TODAY'S DENTAL JSP16-47

Public Hearing at the request of Dr. John Halmaghi for approval of Preliminary Site Plan, Woodland Permit, and Storm water Management Plan. The subject property is located in Section 15 of the City of Novi, south of Grand River Avenue and east of Taft Road, at 44911 Grand River Avenue. The applicant is proposing to construct a 6,688 square foot single-story office building with two tenant spaces and associated site improvements.

PLANNING REVIEW

Revised Preliminary Site Plan Landscape Review

L-1

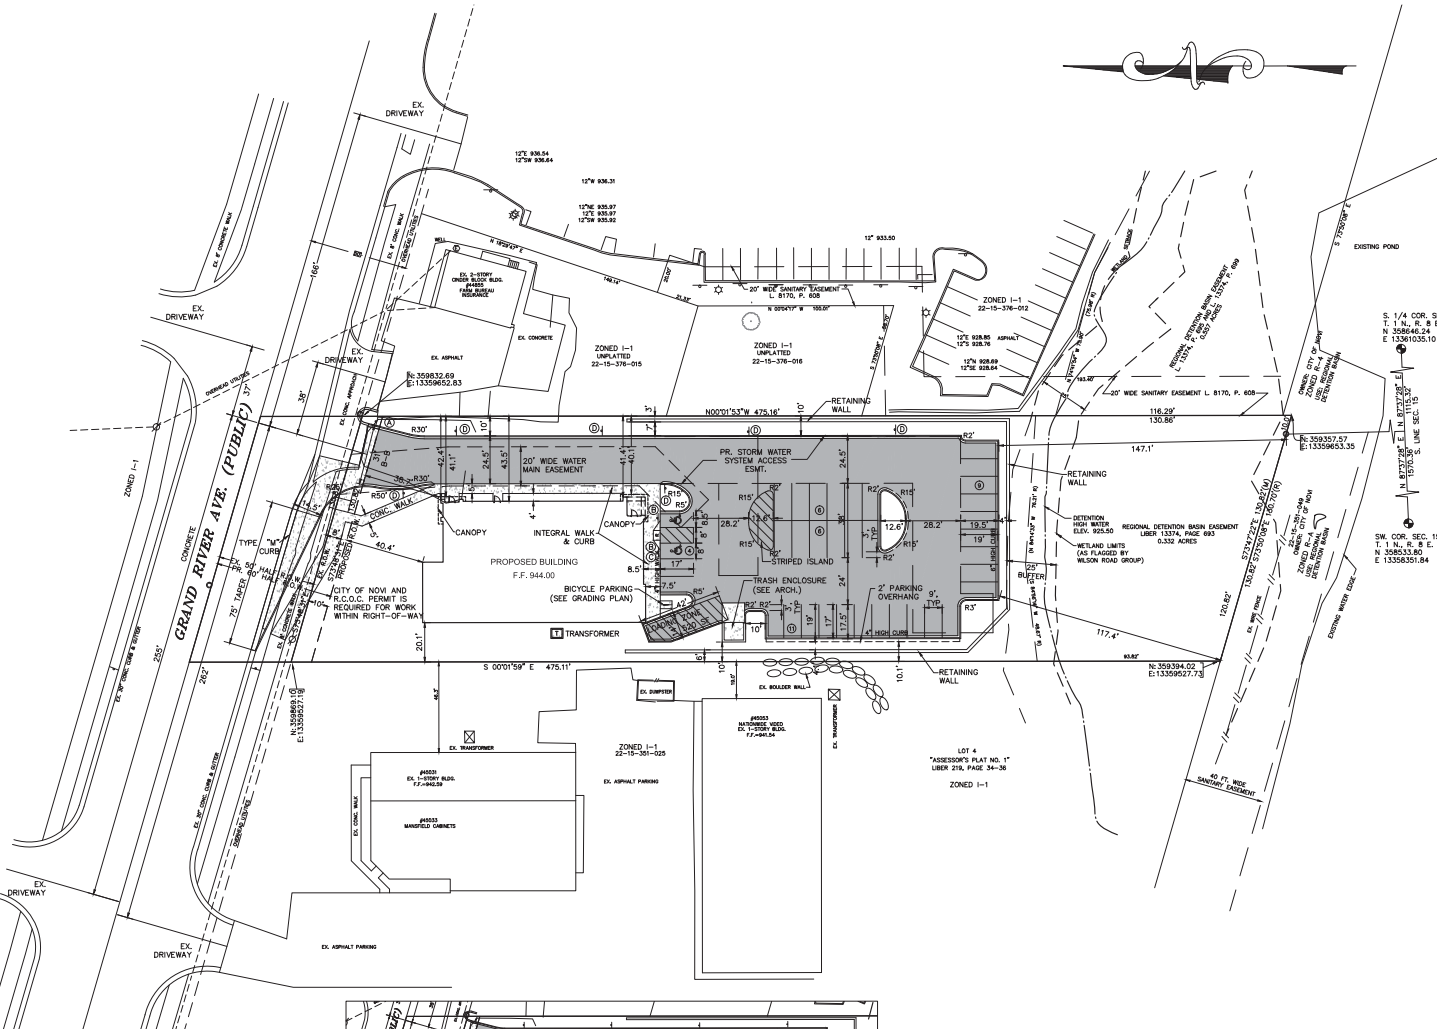
1. A waiver to allow 276 sf of the provided building foundation landscape area in locations not at the building base. *Supported by staff because those areas are behind the building and are only across the access way from the building.*
2. A waiver is required for the lack of an interior parking lot endcap island. *This configuration was arrived at in cooperation with the Fire Marshal so it is supported by staff.*
3. A waiver to not plant the required street tree because of utility conflicts may be requested if conflicts take away any suitable place for the tree. *This would be supported by staff.*

1. A complete tree survey and removal plan is provided.
2. Three existing trees are being preserved at the north end of the site. The wetland at the south end of the site is completely preserved.
3. **In order to improve the view to the wetland south of the site, it is recommended that the applicant remove the dense tangle of large invasive shrubs (mainly honeysuckle) in the preserved area to the south and treat the cut stumps with herbicide to prevent their re-growth. This is not a requirement, but it would add to the visual and ecological quality of the site.**

1. Based on the frontage, less the width of the RCOC sight vision clearance zone, only 1 street tree is required. None are provided.
2. **If there is not room for a tree due to underground utility conflicts, a landscape waiver request for that tree would be supported by staff.**
3. **If there is room for the tree add it. If the RCOC does not allow it, it doesn't need to be planted, but documentation of the RCOC's decision needs to be provided to the city.**

1. As noted above, **please show a line used as the basis of the perimeter.** It should include all of the access drive and parking lot, except for the sections immediately adjacent to the building. Based on this I measure the perimeter to be 613 lf, not 523 lf.
2. **3 additional canopy trees should be located along the access drive north of the building.**

1. Sixteen credits are taken for the 3 trees preserved along the northern edge of the property. This is allowed by the Landscape Design Manual.
2. **Please consider planting the replacement red oak in the wetland buffer instead of in the greenbelt to provide a better environment for its growth and to enhance the ecological benefits it will provide.**

Sheet Title:
Elevations

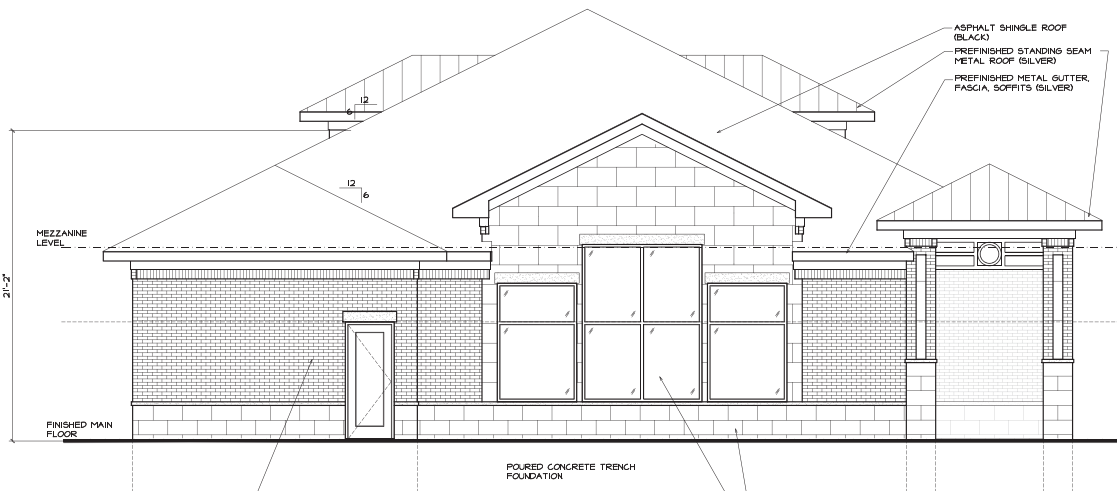
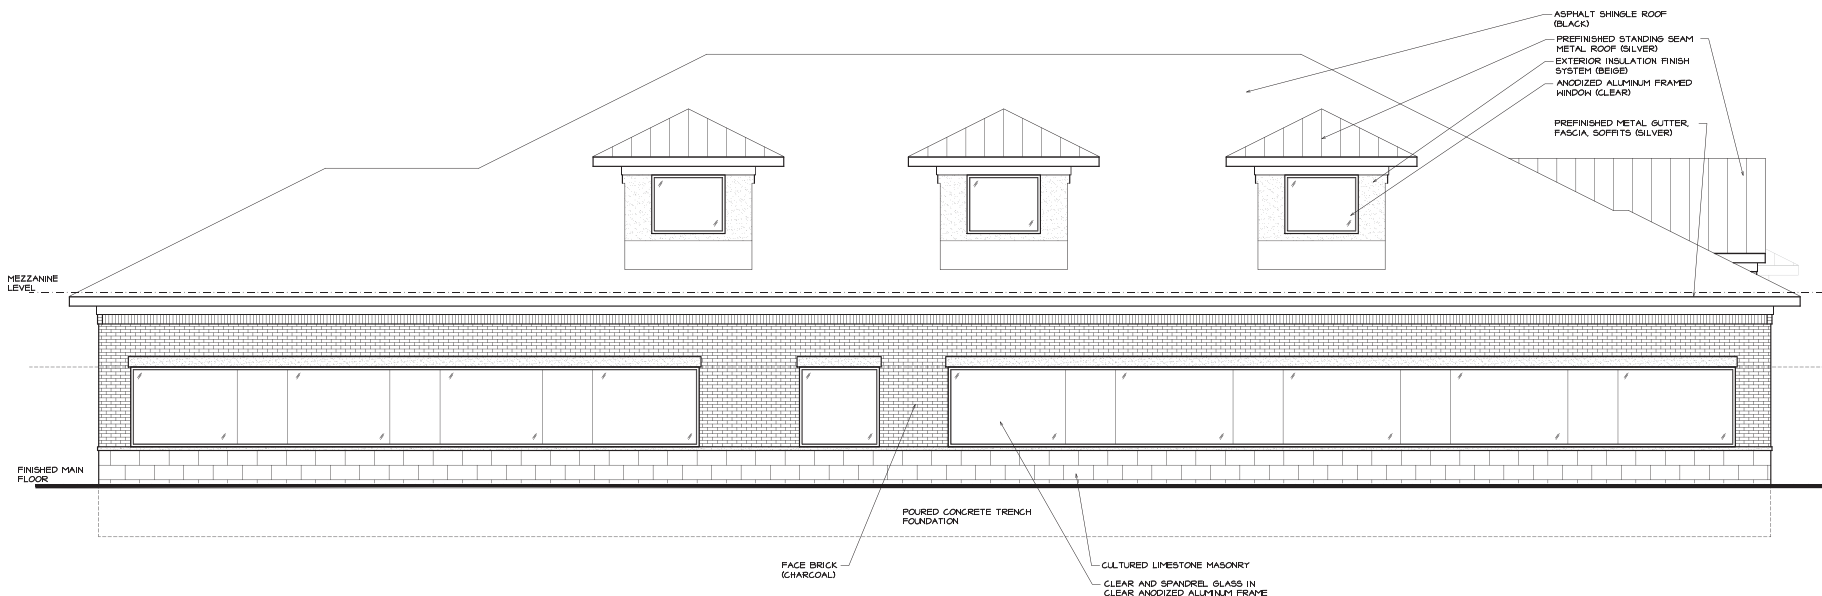
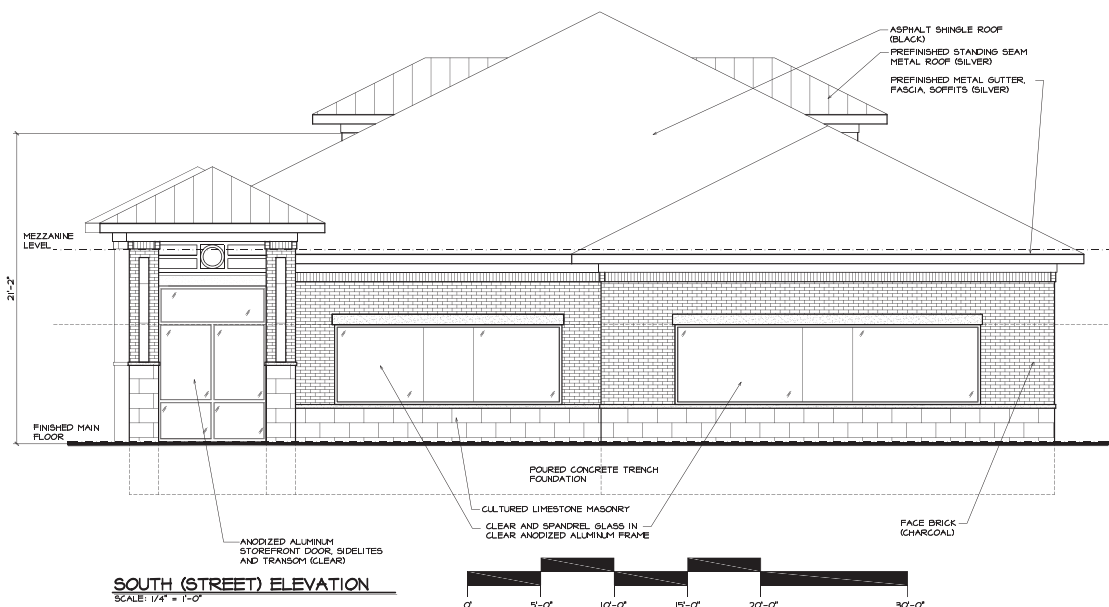
- a. Section 9 Façade Waiver to allow reduction of percentage of minimum brick on West(30% minimum required, 20% provided) and East façades(30% minimum required, 27% provided) because the design is consistent with the intent of Façade Ordinance, which is hereby granted;
